PACIFIC NORTHWEST LNG - ADDENDUM TO THE ENVIRONMENTAL IMPACT STATEMENT

Effects of the Environment on the Project
December 12, 2014

23.0 EFFECTS OF THE ENVIRONMENT ON THE PROJECT

Figure 23-1: Locations of Submarine Landslides and Landslide-Generated Tsunamis (Rabinovich et al., 2003)

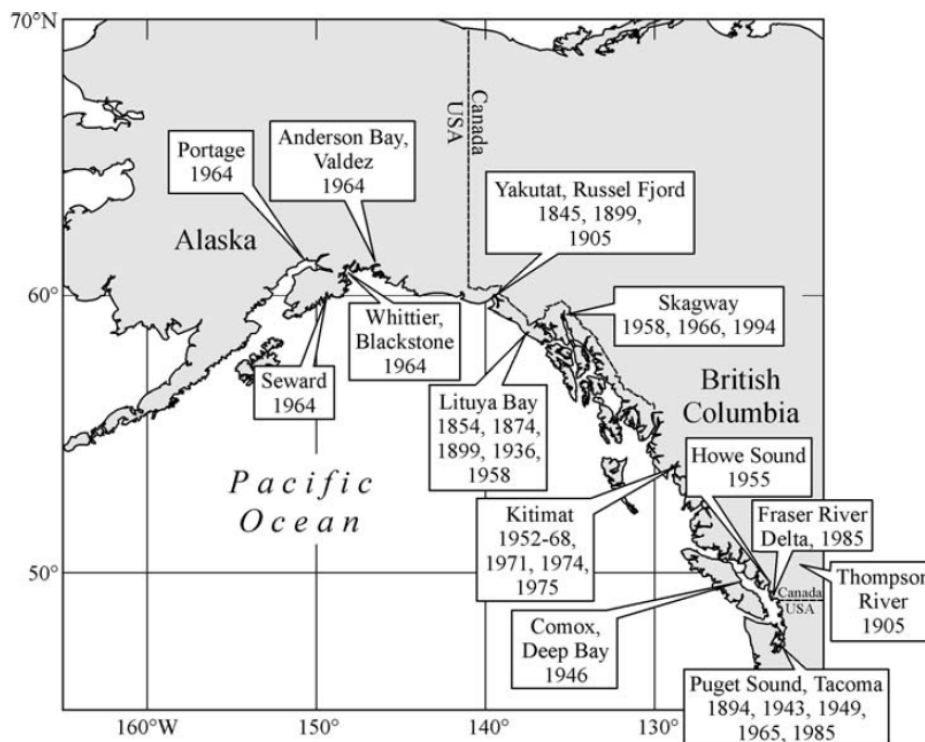
Further consider the potential occurrence of submarine slope failures as a possible tsunami source for Lelu Island. Consult the Conway et. al., (2013) report to determine the threat of tsunamis from submarine slope failures to the site. Conway, K. W., Kung, R. B., Barrie, J. V., Hill, P. R., and Lintern, D. G., 2013, A preliminary assessment of the occurrence of submarine slope failures in coastal British Columbia by analysis of swath multibeam bathymetric data collected 2001-2011: Geological Survey of Canada, Open File 7348.

Discuss the likelihood of such an event exist and what effects it could have on the Project. Also provide any resultant environmental effects this might cause.

Conway et al. (2013) reported slope instability in the form of relatively small slides and debris flows in the Skeena River delta. In consideration of this report and other relevant studies, the threat of a tsunami generated from a submarine slope failure greater than 5 m in height is ranked low for the project site on Lelu Island.

Inlets and narrow straits of the Pacific Coast of North America (e.g., Lituya Bay, Yakutat, Russel Fjord, Skagway Harbour, Kitimat Arm, Puget Sound) contain the greatest potential for landslide-generated tsunamis with relatively large run-up (Soloviev and Go 1975; Lander, 1996; Palmer, 1999; Evans, 2001). Figure 23-1 shows the known submarine landslides and landslide-generated tsunamis along the coasts of Alaska, British Columbia, and Washington.

Known tsunamis closest to Prince Rupert generated from submarine failures occurred in the Kitimat Arm, the head of the Douglas Channel near Kitimat, British Columbia. An investigation after the destructive landslide tsunami of April 27, 1975, in Kitimat Arm, British Columbia demonstrated that such events had repeatedly taken place in this fjord, in particular in 1952 – 1968, 1971 and 1974 (Murthy, 1979; Prior et al., 1981; Johns et al., 1986). The 1952 - 1975 Kitimat landslides and tsunamis occurred during seismically quiet periods. A 2.8 m high tsunami was recorded in Kitimat on October 17, 1974 (Murty, 1979). A 4.1 m high tsunami was observed in Kitimat on April 27, 1975 and it was generated from an estimated 26.0 million cubic meters of slide material (Murty, 1979). Given the geographic separation of the Douglas Channel to Lelu Island (see Figure 2-9 in Appendix I.5), it is expected that any tsunami waves reaching Lelu Island from a potential future landslide event in the Douglas Channel would be negligible.

On November 3, 1994 a submarine landslide resulted in a 5-6 m high tsunami with 9-11 m shoreline waves in the Skagway Harbour, located at the head of the Taiya Inlet (Kulikov et al, 1996). This study reported the tsunami to be confined to the Taiya Inlet and was followed by small-amplitude oscillations. Any potential effects of tsunamis in this area would likely be restricted to the Taiya Inlet.
